CERTIFICATE OF APPROPRIATENESS

Property: 1114 Texas Ave, Tracts 8, 9A, & 11A, Block 70, SSBB Subdivision. The property includes a historic 100,000 square foot sixteen-story office building situated on a 5,990 square foot interior lot.

Proposal: Alteration – Storefront/Windows/Sign

SOUTHWESTERN BELL CAPITOL MAIN OFFICE

NORTHWEST SIDE ELEVATION

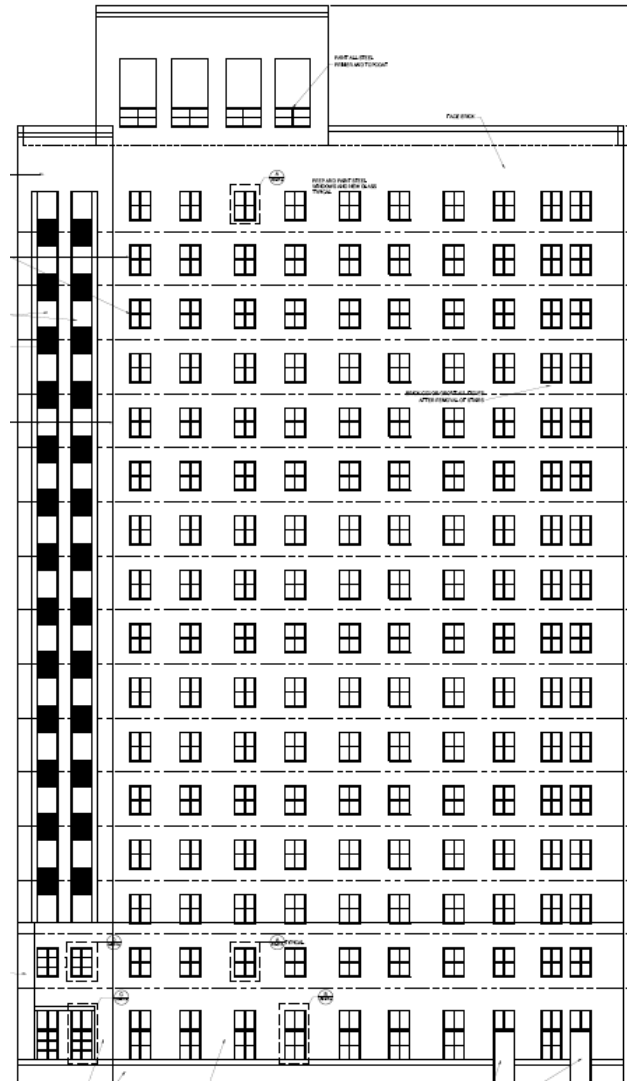
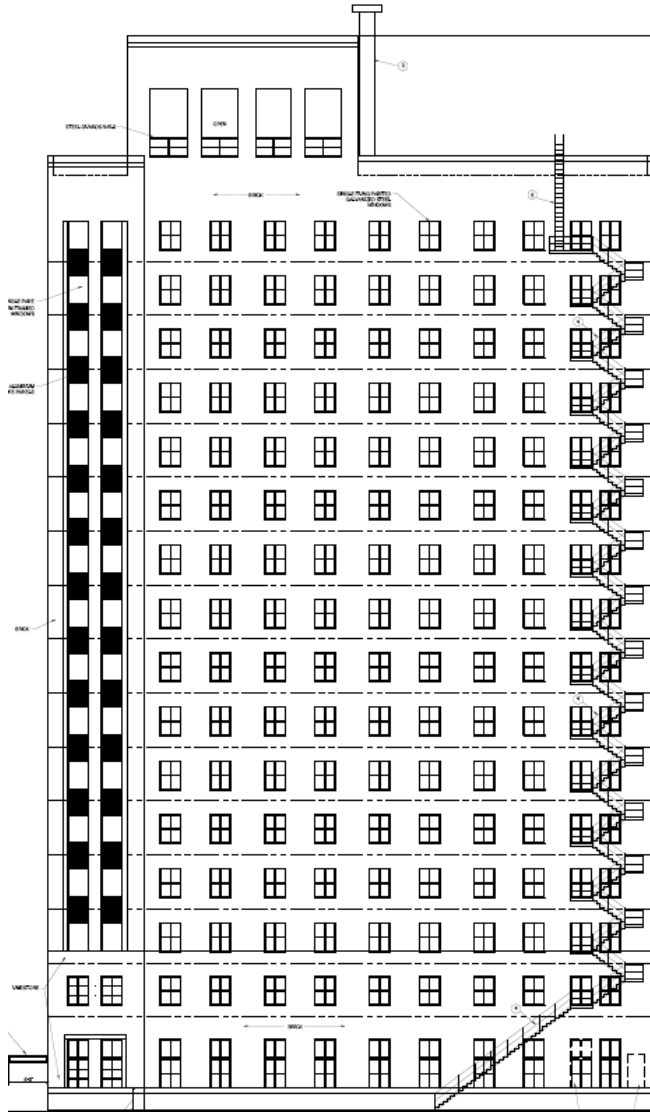
Northwest (side) elevation: The applicant will remove two windows at the southern corner on the first level. The openings will be increased to 7' tall to accommodate doors and create two code-compliant exits.

SOUTHWEST (REAR) ELEVATION

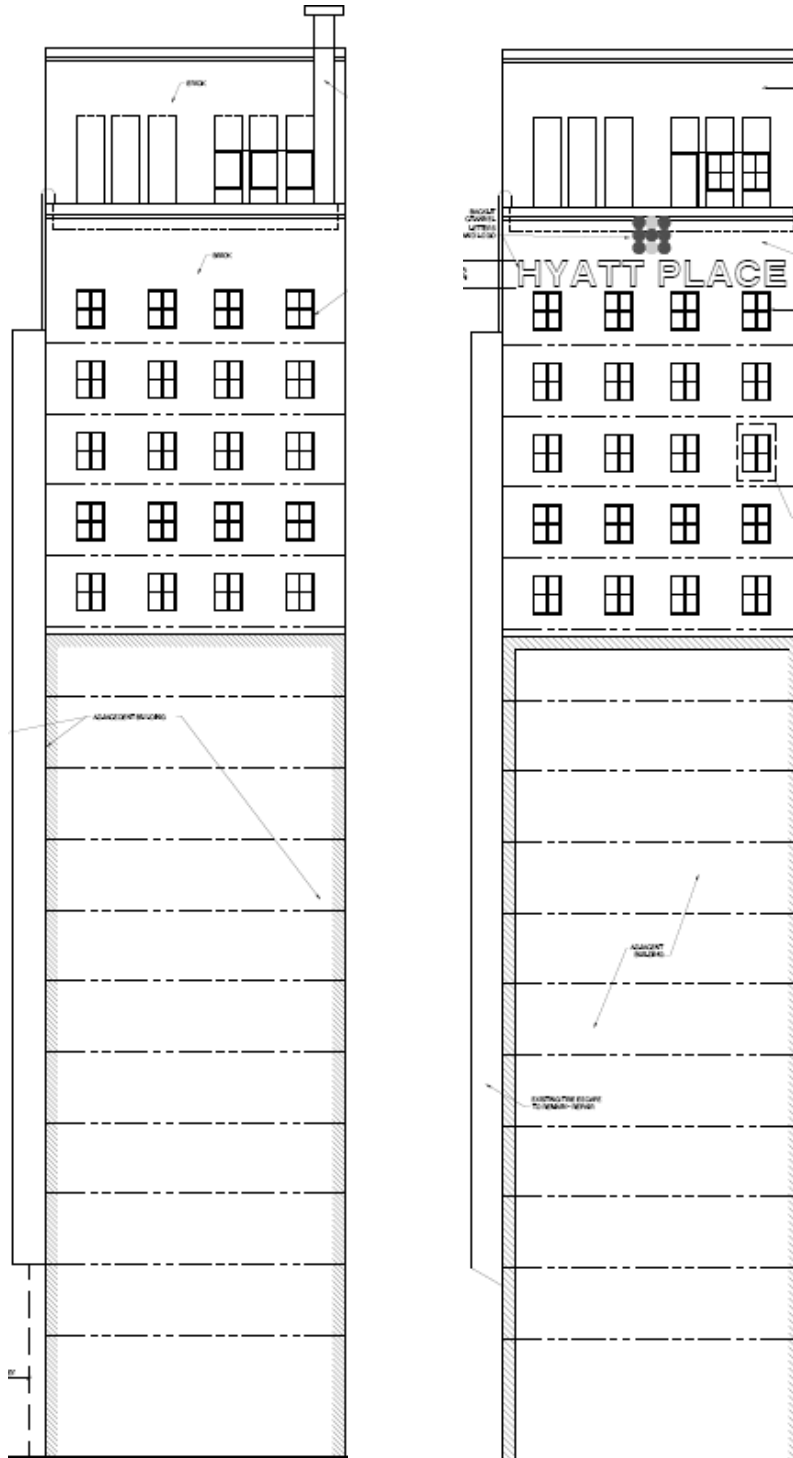
Exterior Materials: The applicant will repair the marble at the base of the northern corner.
The applicant will remove the fire escape from the northwest (side) elevation.
The applicant will install one sign reading "Hyatt Place" on the sixteenth level of the southwest (rear) elevation. The sign will be 4' tall with backlit channel letters.

NEW ALUMINUM FRAME FRONT FACADE WINDOWS AT 2ND FLOOR TO MATCH EXISTING WINDOWS ABOVE IN SIZE AND FINISH AND SETBACK.
WINDOW F

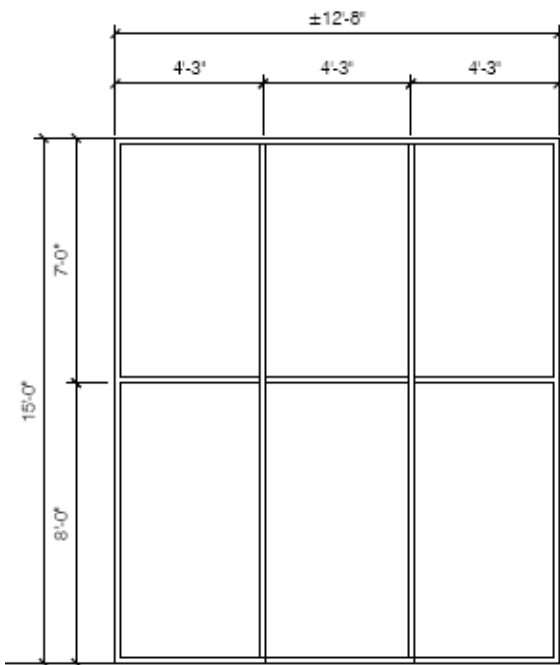
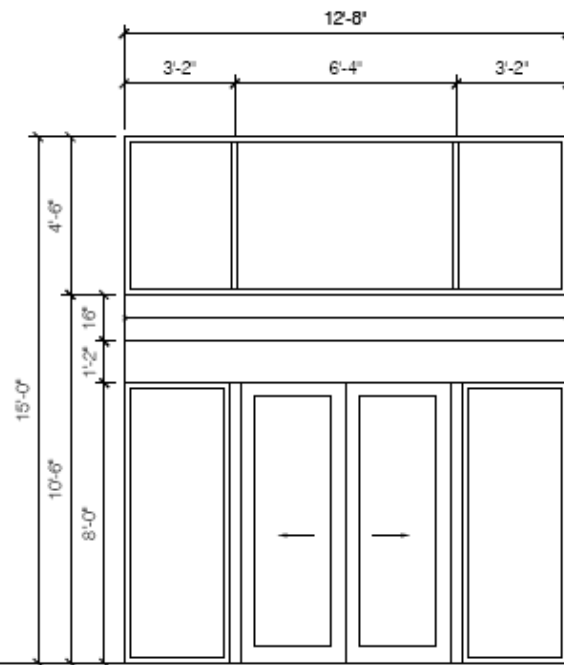
Windows/Doors: Northeast (front) elevation: The applicant will remove the non-original (ca. 1980) entryway. The new entrance will feature full-lite metal doors with sidelights and transom above to fit within the existing opening (15' x 13'). Non-original marble paneling will be removed and new single-lite storefront windows will be installed within a historic opening (15' x 13'). The applicant also proposes to install six aluminum-frame fixed windows to match existing windows above in size and mounting profile.
